**BSR/ASHRAE Addendum c
to ANSI/ASHRAE Standard 41-2020**

Proposed Addendum c to Guideline 41-2020, Design, Installation, and Commissioning of Variable Refrigerant Flow (VRF) Systems

**First Public Review (July 2022)
(Draft shows Proposed Changes to Current Standard)**

Figure 4 Climate zones for United States counties

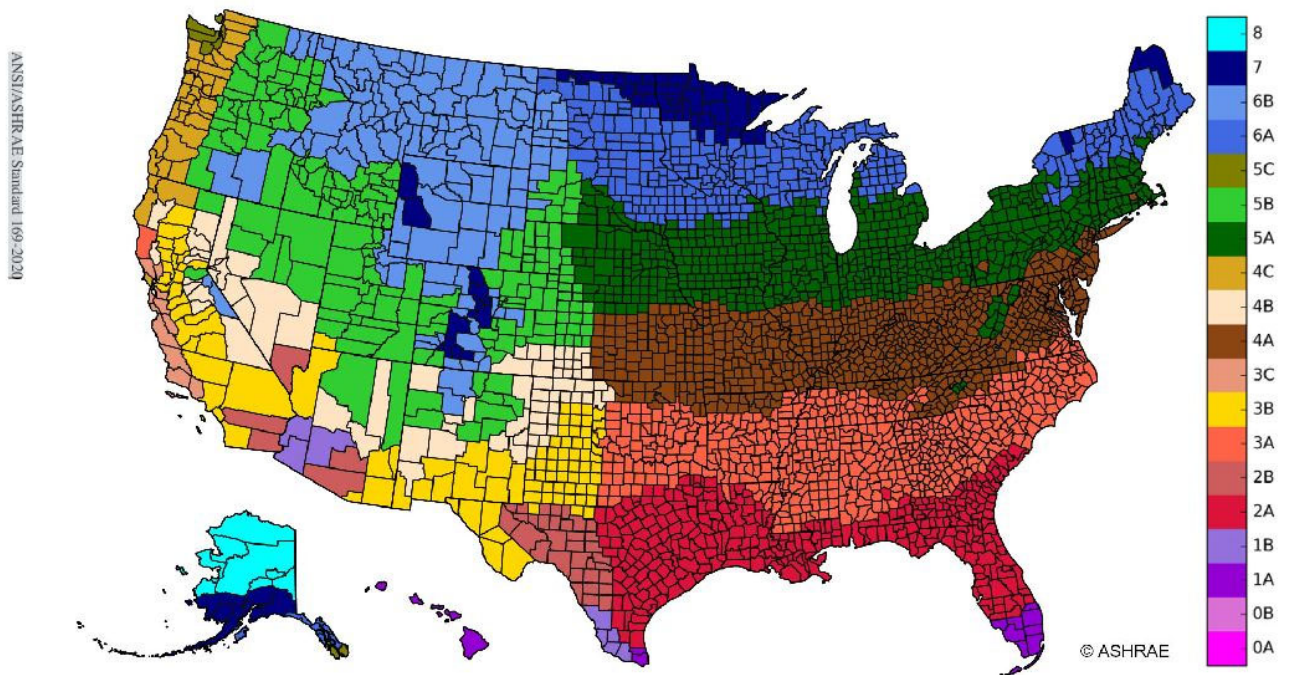
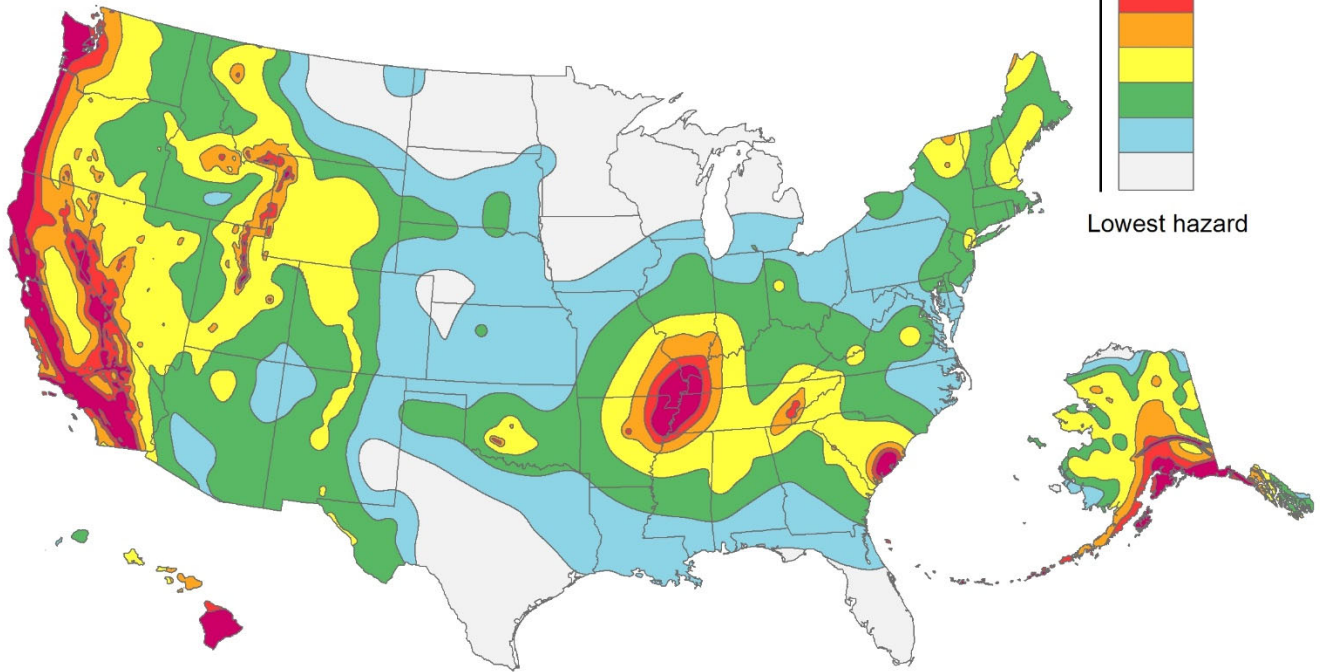
This addendum updates Figure 4, Climate zones for United States counties, from ASHRAE 169-2020. This addendum also updates Figure 9, U.S. seismic hazard maps, from the US Geological Survey 2018 Hazards Map.
